NHDOT / ACEC-NH Bridge Subcommittee Meeting Minutes

June 8, 2018

Second Quarter Meeting 2018 (4th meeting of this subcommittee)

DECK OVERHANG DETAIL (PRECAST DECK PANEL)

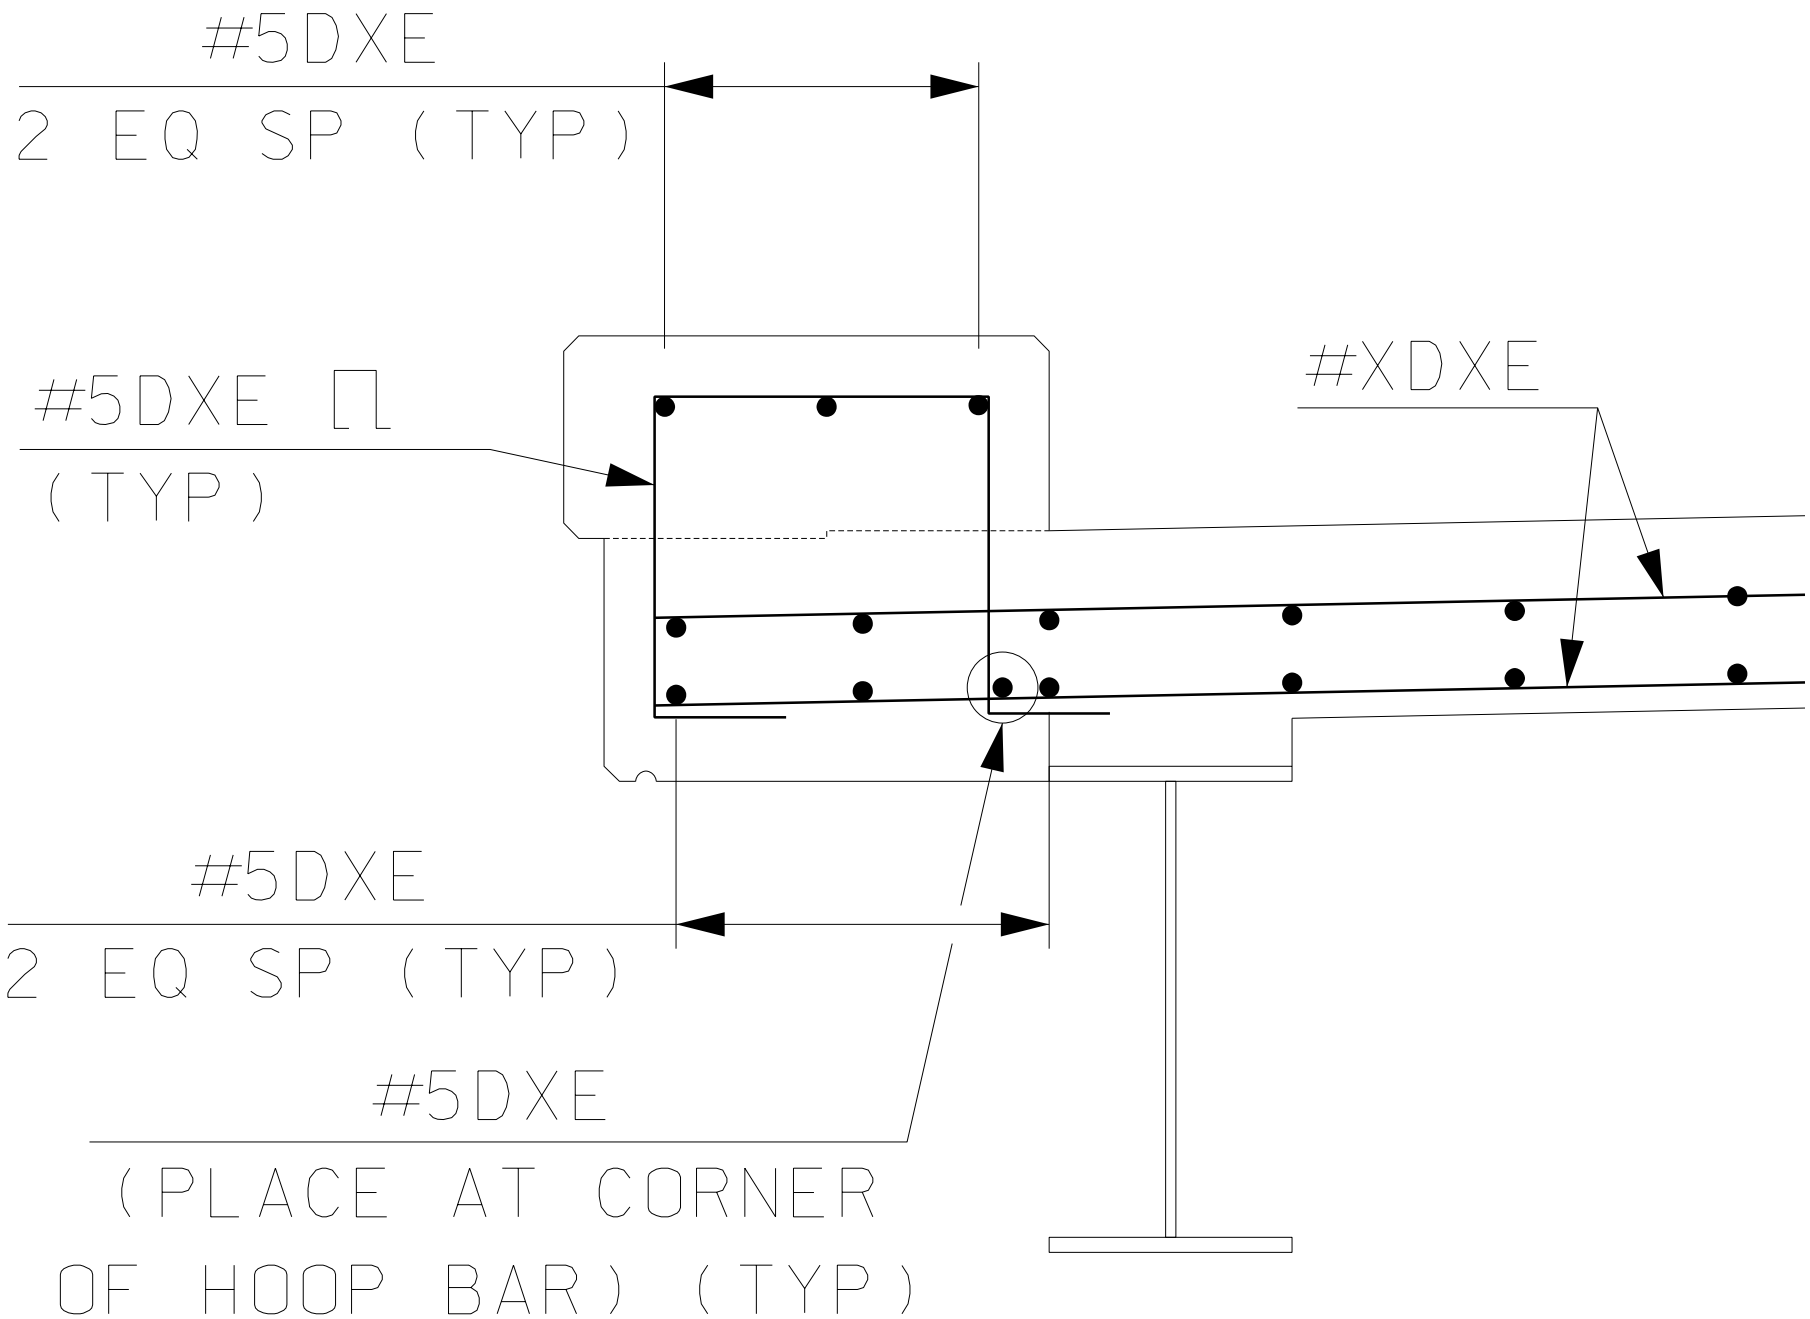
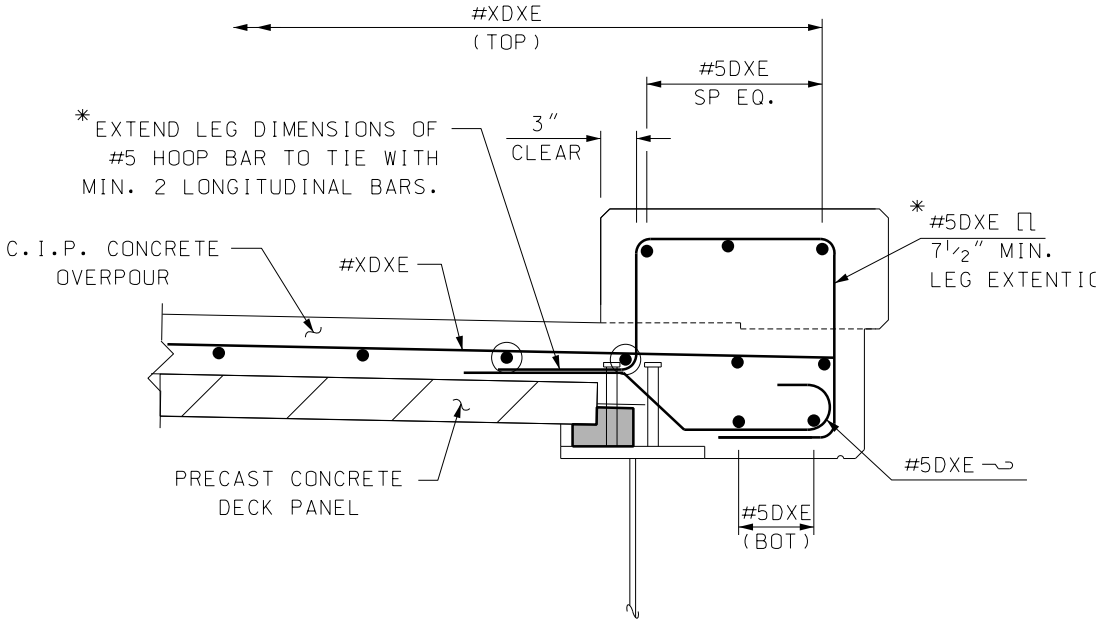
- We need to match what was crash tested for the bridge railing in all our projects. The hoop bars shall be dimensioned so the legs tie to the bottom transverse bar and an extra longitudinal bar shall be called out to tie at the corner of the front hoop leg. The deck details will show this.

- The details will also show a double hook reinforcing bar for the bottom mat with precast panels. For short overhangs (< 2.5') the detail shows a bent hook bar. Decks without precast panels do not require a hook bar as long as the minimum deck steel (#5 at 6") is provided per the crash test of the railing.

- Steve Hodgdon suggested instead of a bent hook bar to use a straight hook bar tied to the top mat and a u-shape bar on the bottom.
  - *Subsequent to the meeting, NHDOT Bridge Design Bureau discussed the precast panel overhang detail that shows a bent hook bar. It was decided to keep the bent hook bar as shown since it is tied to the hoop bar leg (bottom and top) and will help in pull-out during a crash load on the railing. This bent*

bar is only needed for overhangs< 2.5' otherwise a double hook bar can be used on the bottom and the hoop bar leg tied to it.

*DETAIL SHOWN FOR DECK OVERHANG LESS THAN 2'-6". CURB HOOP BAR SHALL BE TIED TO THE BOTTOM LONGITUDINAL DECK BARS WHEN POSSIBLE.

SECTION B-B

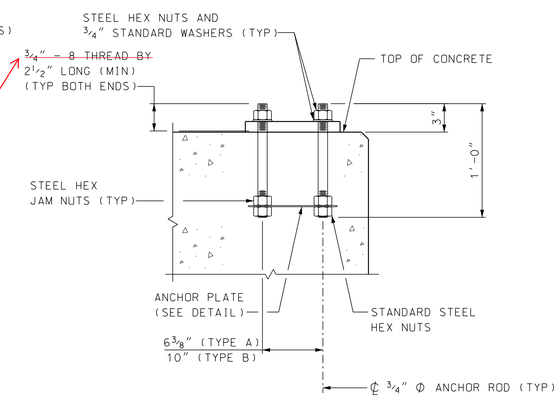
- Anchor Rods:
    - If calling out an anchor rod, make sure the size of the bolt and thread length are a common in-stock item. Soundwall plans showing anchors for a bridge curb are calling out an anchor that is not in stock. NHDOT will be noting this on the sample plan on-line.

Incorrect thread series for 3/4" bolt. Do not call out thread series.
